STARBUCKS SITE IMPROVEMENTS

ROBERT B. AIKENS AND ASSOCIATES
 350 N. OLD WOODWARD
 SUITE 300
 BIRMINGHAM, MI 48009
 TELE: 248-283-2387
 CONTACT: JAMES FIELDER
 EMAIL: fielder@rbaikens.com

5 SHEET OF 9

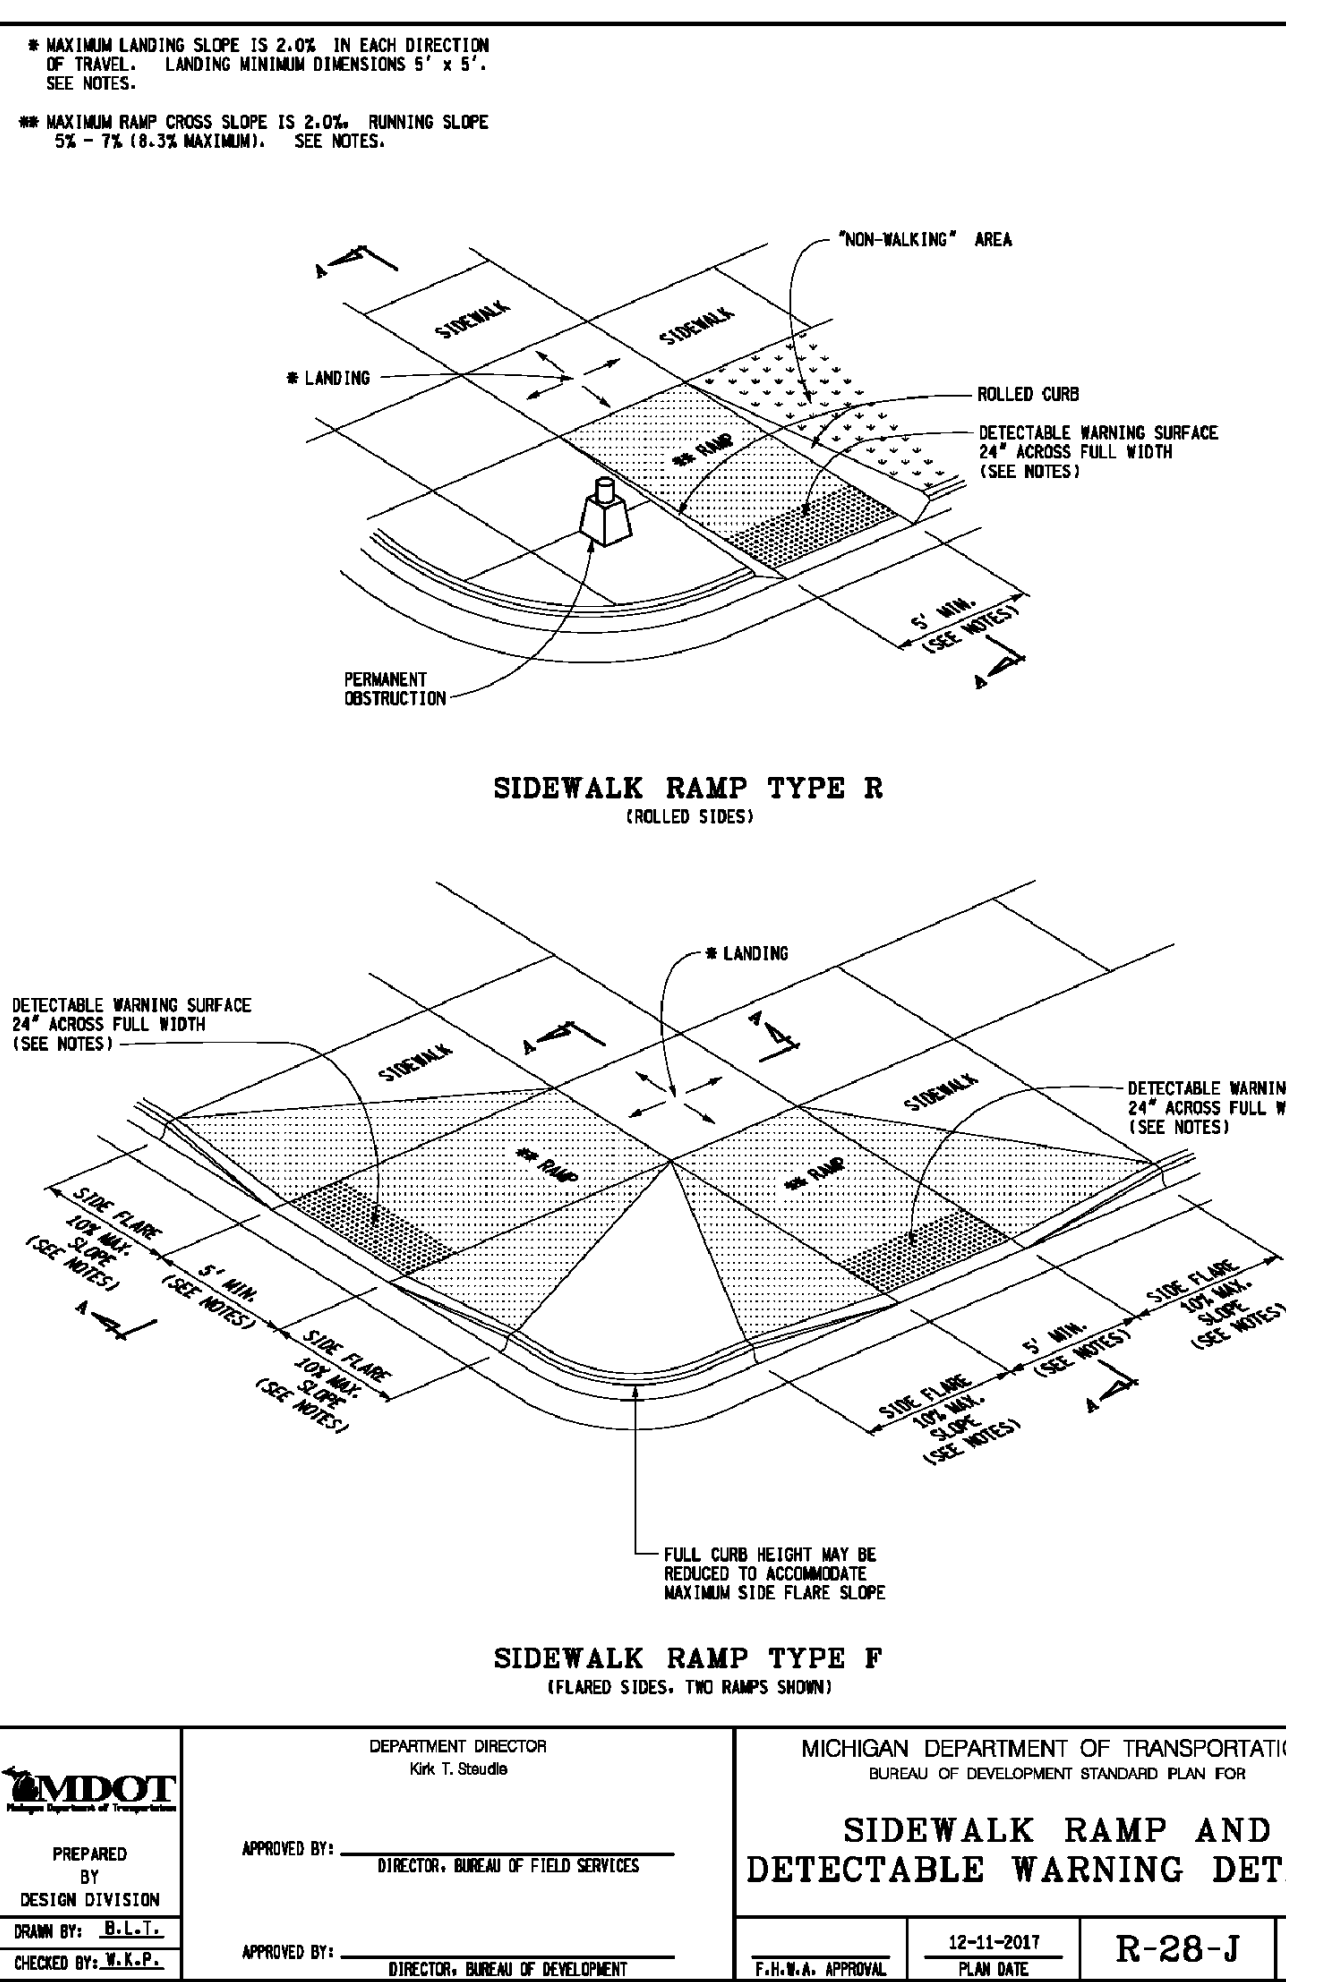
CAR	REVISED PER CITY REVIEW COMMENTS	2-3-22
BY	MARK	DATE
